UNECE Regulation 53

DRL auto switch

With the present informal document, Italy would like to better specify and clarify the reasons for his objections to the Japanese proposal.

Motorcycle with Cockpit and Windscreen – Instruments Directly Face the Rider (sensor therefore in shadow)

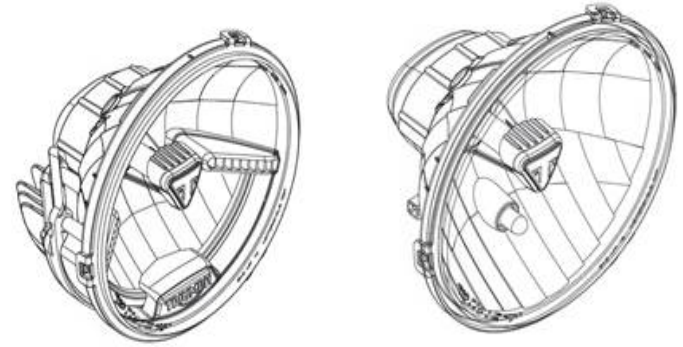
In the instrument pack, it is more protected from contamination but is likely to be in shadow, either from the rider and/or from surrounding bodywork and windscreens, especially those windscreens which are tinted. This will lead to the headlamp being on in conditions where the DRL could/should be on. The net result would be that , although a DRL may be fitted, there will be very few occasions when it will actually function.

Lamps with (left) and without (right) DRL

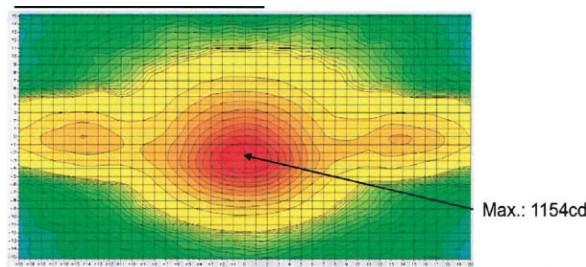
For the same motorcycle model, a headlamp with a reciprocally incorporated LED DRL has a unit cost to the manufacturer 6 times higher than for the same unit with a headlamp and position lamp using bulb light sources and with no DRL.

If the automatic switching apparatus is added, this rises to 10 times higher than for the basic non-DRL lamp fitted to the same motorcycle.

PHOTMETRIC SIMULATION DRL (R87)

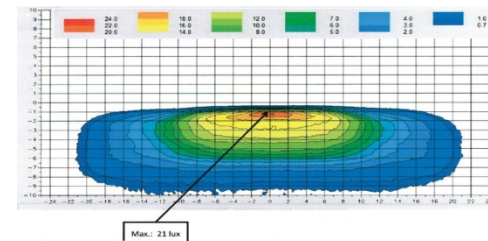
As can be seen, the daytime conspicuity device (DRL) is required to provide light in H/V grid areas where the amount of light is deliberately controlled in a night time illumination device (low beam headlight). In other words both lamps are good for one purpose and not necessarily for the other.

However the emission of light in the glare critical zone for an oncoming vehicle is quite always lower for a DRL than for an headlamp; consequently the switching from DRL to headlamps do not ensure to solve the disturbance problems claimed by the Japanese study.
